CERTIFICATE OF THE SECRETARY OF ENERGY AND ENVIRONMENTAL AFFAIRS  
ON THE  
FINAL ENVIRONMENTAL IMPACT REPORT

PROJECT NAME : Cape Cod Gateway Airport (formerly Barnstable Municipal Airport) Master Plan  
PROJECT MUNICIPALITY : Barnstable (Hyannis)  
PROJECT WATERSHED : Cape Cod  
EEA NUMBER : 16640  
PROJECT PROPONENT : Cape Cod Gateway Airport  
DATE NOTICED IN MONITOR : October 9, 2024

Figure 2. PFAS6 and PFOS in Deployment Area Monitoring Wells and the Maher ME2 Well. Map (from Airport)

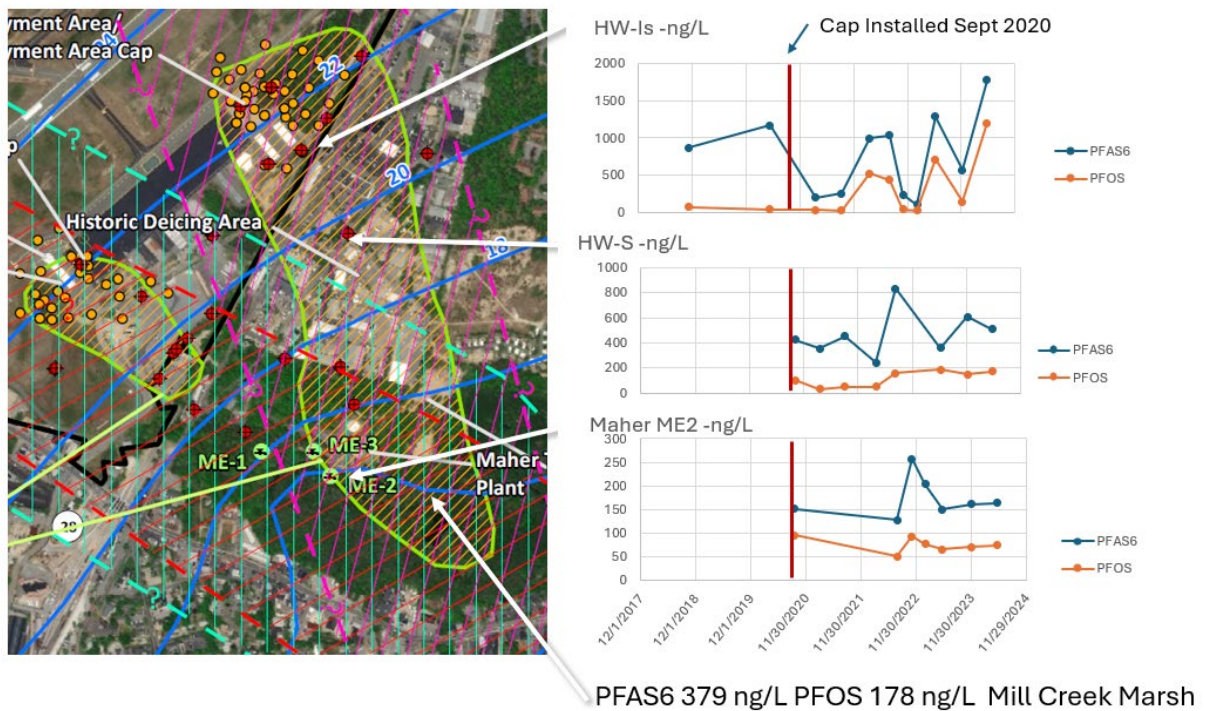
A more detailed evaluation of the Airport’s monitoring results from June 2023 indicates a significant increase of legacy AFFF PFAS6 components, including PFOS, in the identified Deployment area wells HW-Is and HW-S (Figure 2). The Airport consultant’s reports and

The series of graphs of Figure 2 showing PFAS 6 and PFOS in the source well HW-Is, Intermediate well HW-S and HPCA Mill Creek System PFAS results raises some questions about the Airport's predictive groundwater model of PFAS and its use in weighting the evidence to make their PFAS contamination appear so exclusive. The groundwater solute transport model was not well documented in the Phase II report. The model used the highest observed PFAS6 concentration in the plume and reported the computed downgradient concentrations in a predictive mode. The computed concentrations were not compared to observed concentrations, as typically conducted in modeling to validate and verify the model's capability. The conclusions from the modeling effort stated:

Figure 3 Graphic From Airport's Phase IV Report concluding significant PFAS reduction from the Cap Installation focusing on the non-regulated 6:2 FTS

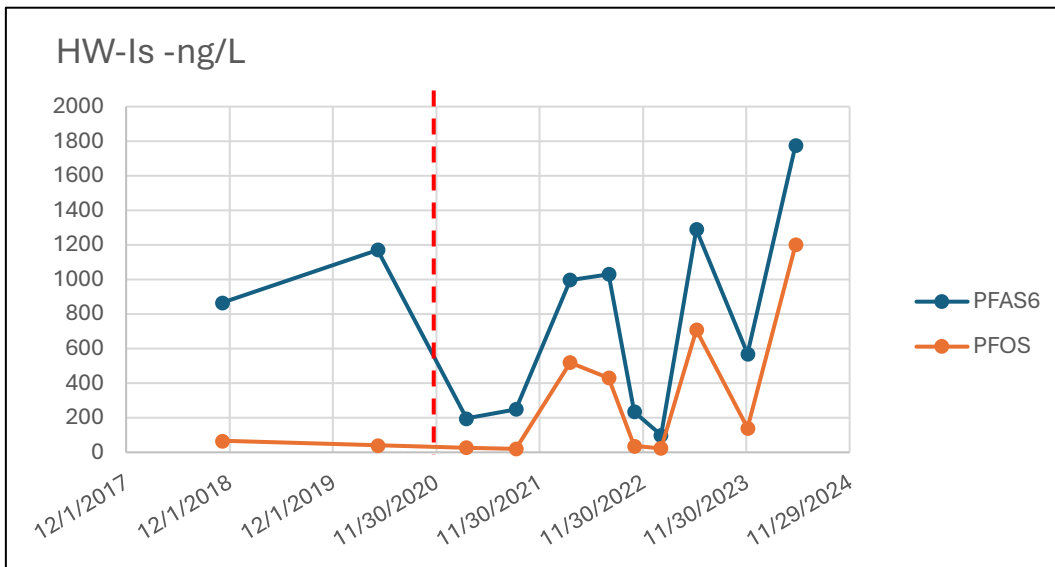
However, the regulated PFAS, PFAS6 and PFOS among others show continuous release and increasing concentrations exceeding the 20 ng/L Maximum Contaminant Level after the cap was installed (Figure 4).

Plan view of the Maximum Extent of the PFAS Sum of Six Plume from the Deployment Area and ARFF/SRE Area:

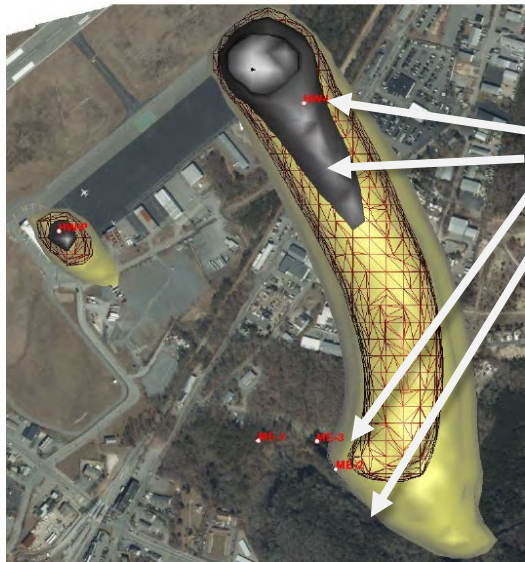
The recent PFAS6 concentrations are compared to the predicted PFAS 6 concentrations from the model as depicted in Figure 5. The model was used to demonstrate reduced PFAS6 concentrations along the plume flow path at its maximum extent (Figure 5). Because PFAS6 includes five other compounds, the comparison includes PFOS and the Airport's 6:2 FTS (Table 1). The predicted maximum PFAS6 concentration at the source well, HW-Is, is 200 ng/L, the actual PFAS6 concentration in June 2023 is 1,290 ng/L/ The model predicts a PFAS6 concentration of at less than 20 ng/L in Maher ME2, while the actual PFAS6 concentration in December 2023 was 161 ng/L. The model indicates that the PFAS6 concentration of discharge into Mill Creek Marsh is 20 ng/L, but the June 2024 PFAS6 concentration is 379 ng/L.
